**From:** [Rob Smith](#)  
**To:** [Planning](#)  
**Subject:** 2019/0534/cvc  
**Date:** 11 November 2019 14:27:43

**From:** Jack Blow  
**Sent:** 11 November 2019 14:25  
**To:** Julia Beaumont  
**Cc:** Rob Smith;  
**Subject:** RE: Woodsmith mine phase 11

**NORTH YORKSHIRE COUNTY COUNCIL**  
**BUSINESS and ENVIRONMENTAL SERVICES**  
**LEAD LOCAL FLOOD AUTHORITY**  
**CONSIDERATIONS and RECOMMENDATION**

| <b>Proposed Development:</b>   | <p>Application for verification check of conditions 4, 18, 29, 34, 45, 46, 47, 52, 57, 60, 64, 68, 70, 71, 73, 76, 79, 81, 87, 91, 92, 93, 94, 95 and 97 of planning approval NYM/2017/0505/MEIA at Land at Woodsmith Mine (formerly Doves Nest Farm &amp; Haxby Plantation), Sneatonthorpe (minehead); underneath 252 km2 of the NYMNPA (winning &amp; working of minerals); a corridor extending underground from the edge of the NP boundary to Wilton Complex (mineral transport system); Ladycross Plantation near Egton, Lockwood Beck Farm near Moorsholm, Tocketts Lythe, near Guisborough (intermediate shaft sites); site within the eastern limits of the Wilton Complex, Teeside (tunnel portal)</p> |                          |  |

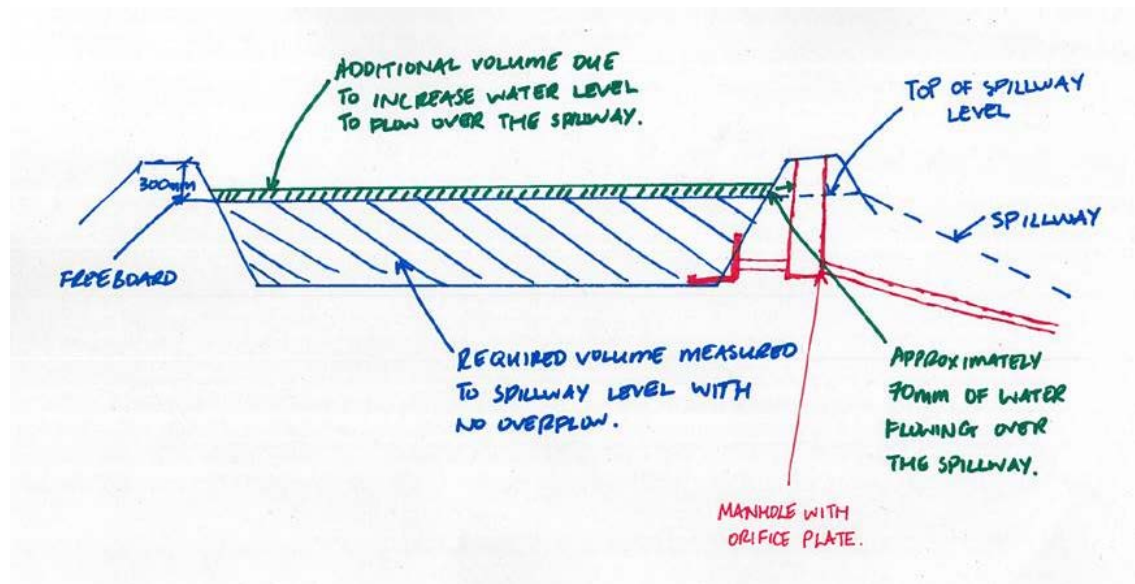
- Our current model is built such that any flooding on site is lost and it is not recaptured within the network, this is due to the limitations of the modelling software. If an overflow was introduced to loop the larger flood volumes back into the network, the volume will re-enter the system instantly when simulated. This will not emulate how the water will flow over the surface and the associated attenuation before reintroduction into the network. We have taken the view that the all the flood volume within the site is contained within the platform boundary and will therefore all pass through the oil interceptors before discharging to the attenuation ponds. We have also taken the view that this relatively small volume in relation to the size of the site would not increase the final discharge rate significantly.

To confirm the above assumptions, we have added an overflow into our model from pipe PH3-N-1.017 to overflow to pipe PH3-N-17.007 (this is the section of ditch that we expect the flood volume will flow over the platform to) to confirm how the network reacts. We have simulated this for the critical storm event in the 1 in 20 year return period and the results are attached (Revised with 150m<sup>3</sup>). The simulation shows there is now some flooding on the eastern platform ditch PH3-N-17.008 and PH3-N-17.009 of 23m<sup>3</sup> and 22m<sup>3</sup> respectively. This flooding will be contained within the free board of the ditch, which is not included in the model. Additionally, the ditch is in a small valley containing any flooding from the ditch in the platform area. The simulation also shows that the overall discharge rate off the site has not been significantly affected. As noted above we do not consider this a realistic representation of how this flood volume is captured on site. Introducing this flood volume into the model has not had a significant affect to the overall performance of the model and the final discharge rate.

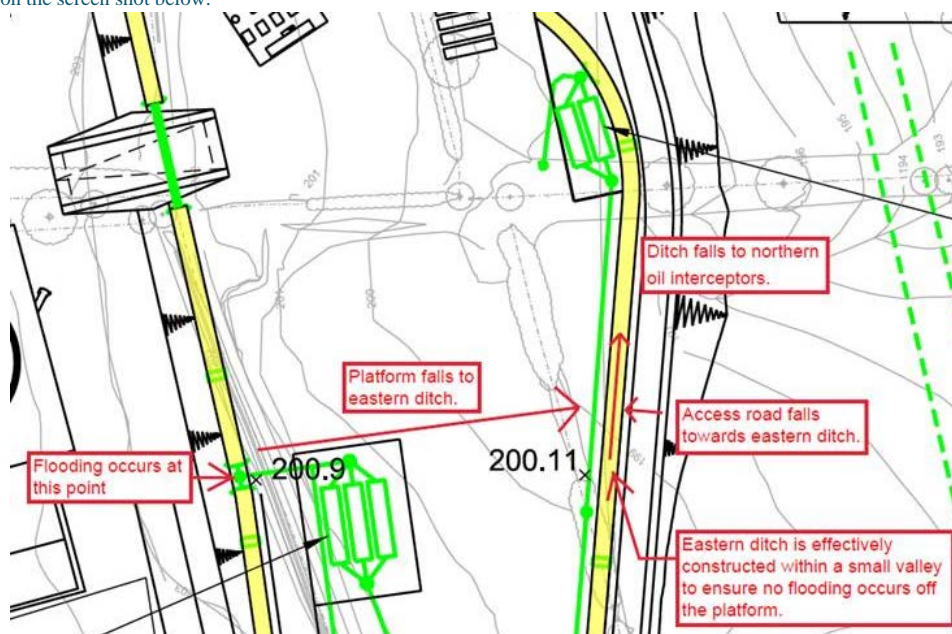
- Flooding from pipe PH3-N-1.017 occurs at the point where an open cut platform drainage ditch outfalls into a piped drainage section and the 3no. oil interceptors. All the ditches were constructed with 300mm freeboard which is not included within the MicroDrainage model calculations and therefore some of this volume will effectively be held within the ditch. The remaining flooding volume will still be contained within the overall platforms area, with the natural fall across the lower platform been in a easterly direction. Any flooding will natural fall in an easterly direction across the lower platform and be collected in the lower platform drainage system as illustrated on the screen shot below.

This ditch is located within a small valley, bounded by the platform to its west and a surfaced access road formed of compacted mudstone to its east and therefore if this ditch was to overtop, any flooding will be contained by ponding within the valley and on the platform. It should be noted that both the platform and access road fall towards the drainage ditch. The eastern platform drainage ditch outfalls through the 2no. northern oil interceptors before discharging into the main site attenuation ponds.

How does the model represent the overland flow being captured by the ditch? How is it ensure that the 150m<sup>3</sup> is not lost from the model and re-introduced into the ditch
